STERLING RANCH RD & BRIARGATE PKWY.  
SEGMENT 2 GESC  
GRADING AND EROSION CONTROL PLAN  
ADDENDUM

DESIGNED BY	MAW	SCALE	DATE	4/29/24
DRAWN BY	MAW	(H) 1" = 100'	SHEET	4A OF 9
CHECKED BY	(V) 1" = N/A	JOB NO.	1183.30

STERLING RANCH RD & BRIARGATE PKWY.  
SEGMENT 2 GESC  
GRADING AND EROSION CONTROL PLAN  
ADDENDUM  
DESIGNED BY MAW SCALE DATE 4/29/24  
DRAWN BY MAW (H) 1"= 100' SHEET 4B OF 9  
CHECKED BY (V) 1"= N/A JOB NO. 1183.30

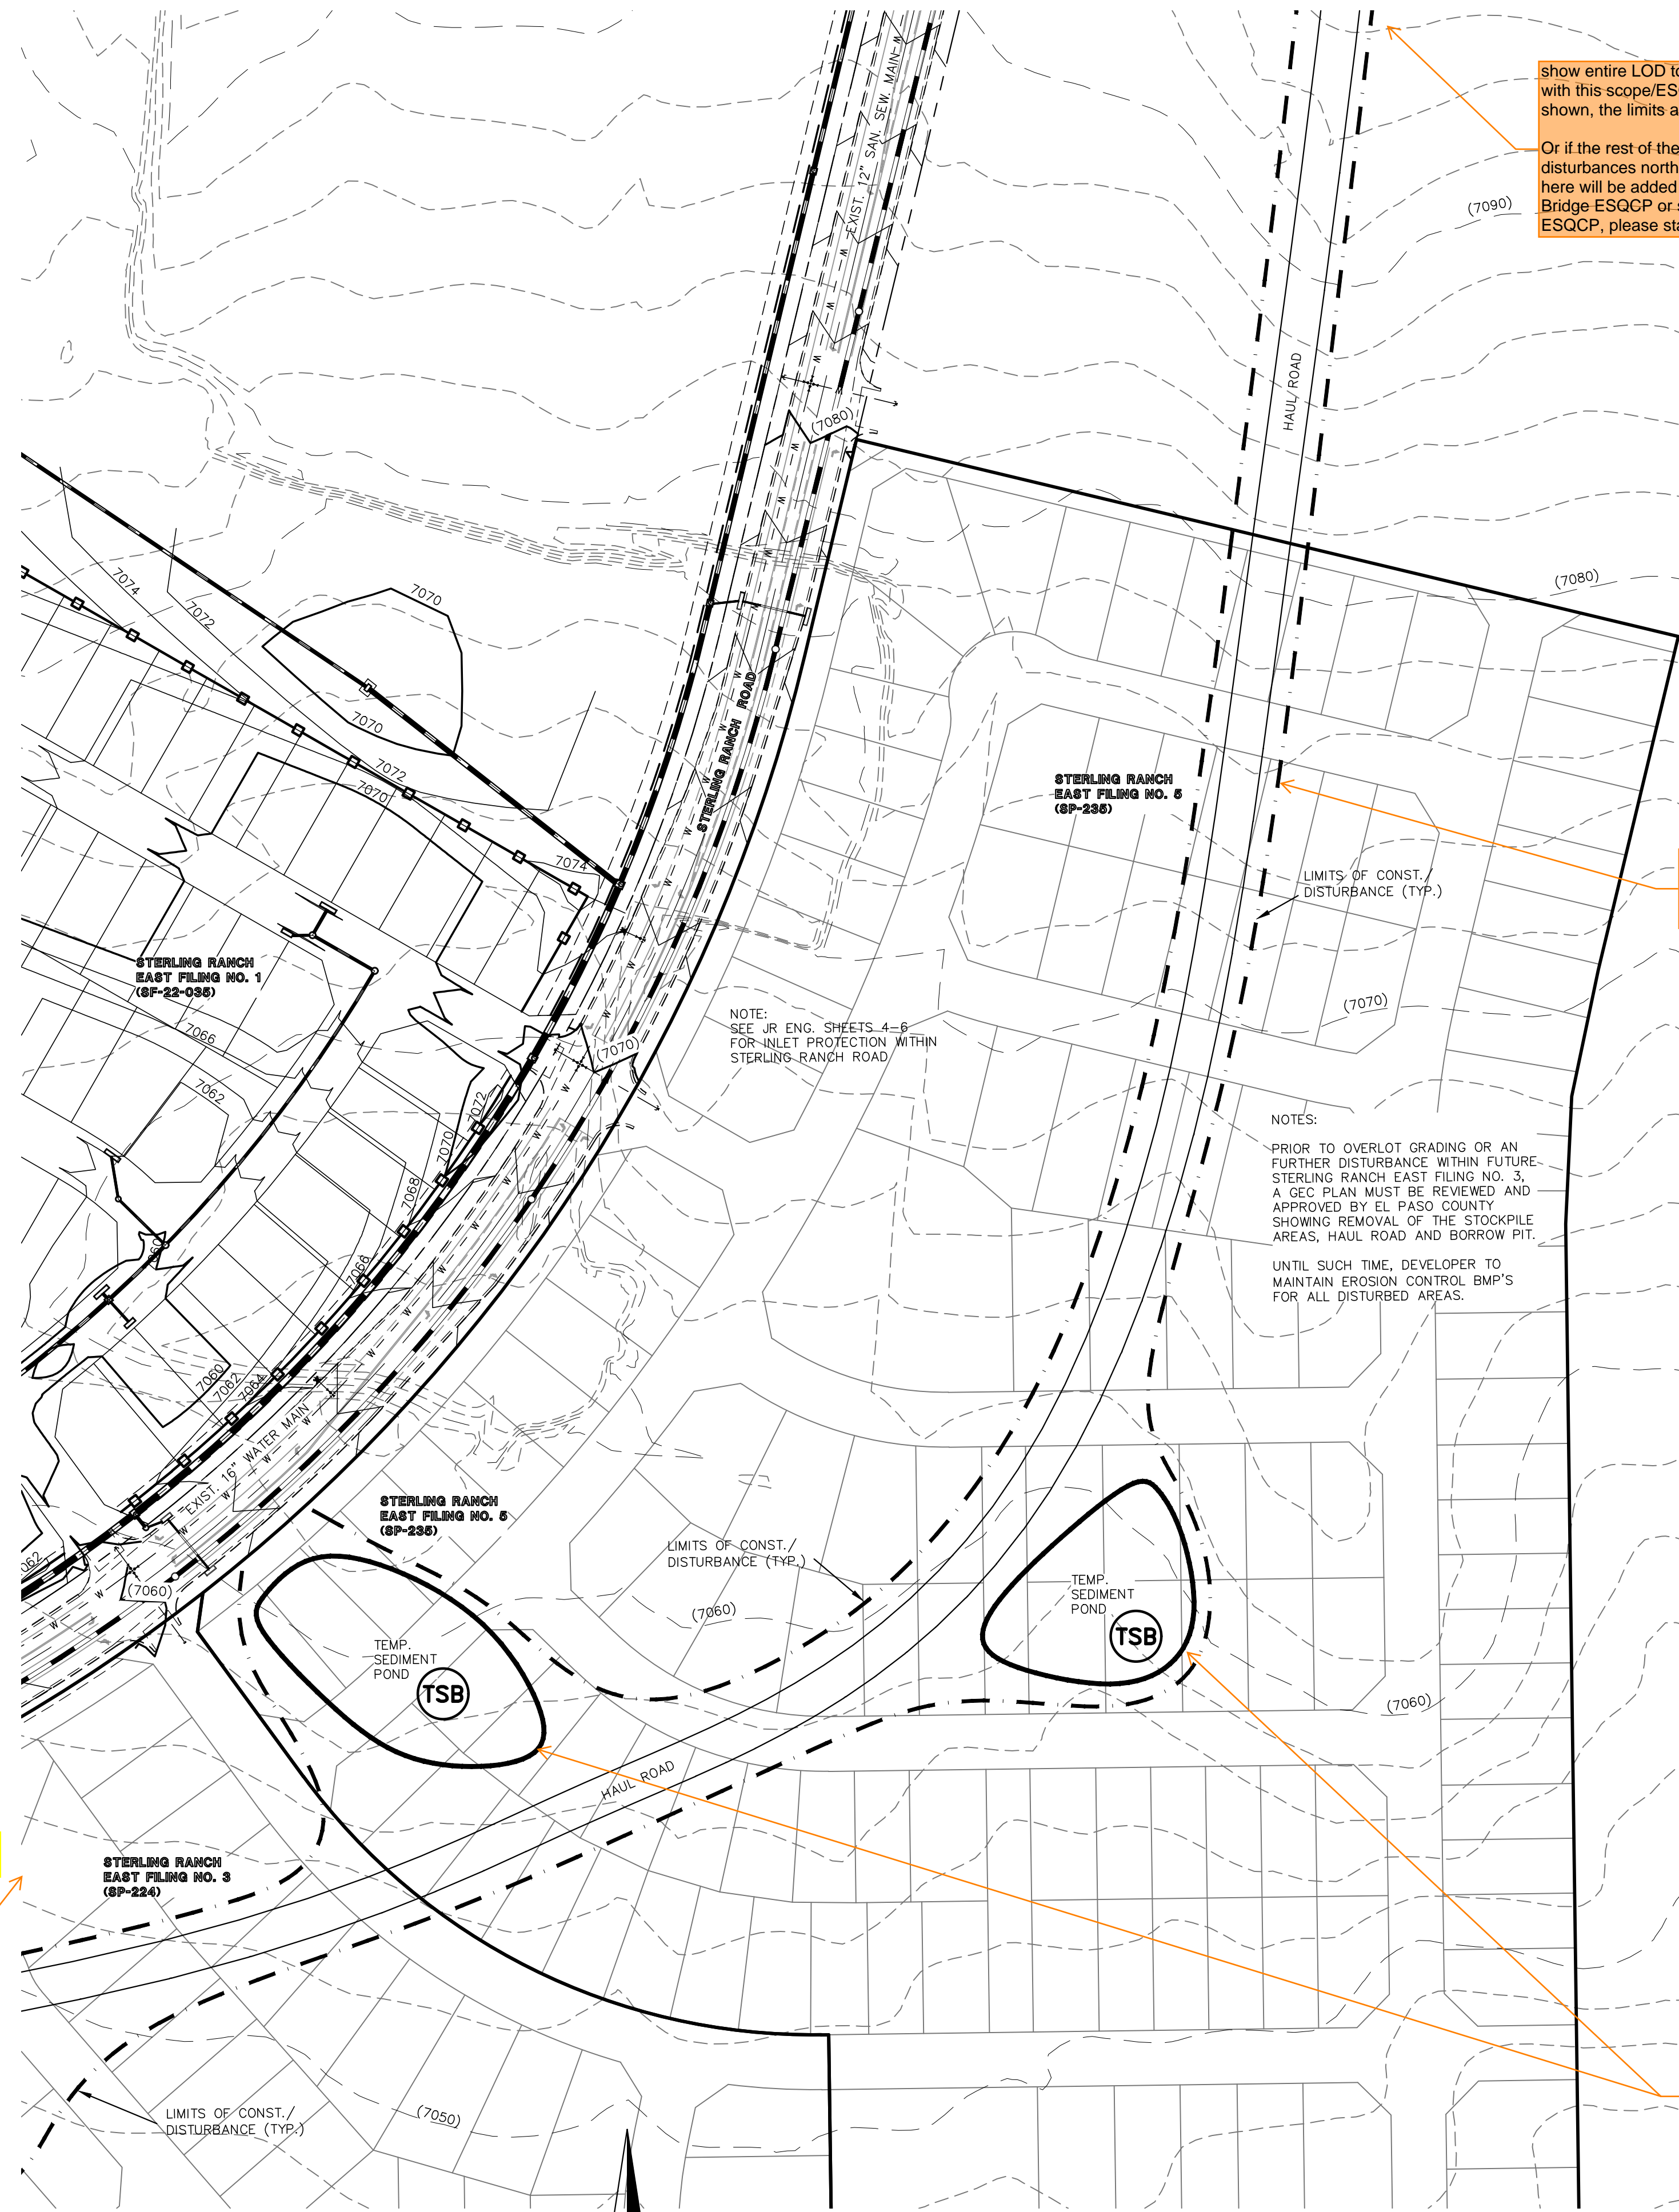
See comment on previous page regarding TSBs.  
Also, runoff tributary to these TSBs previously sheet-flowed across the surrounding land. Now the TSBs will discharge these flows as a concentrated flows. Please address this by providing a suitable outfall (riprap apron, flow path via swale) and/or some form of level spreader.
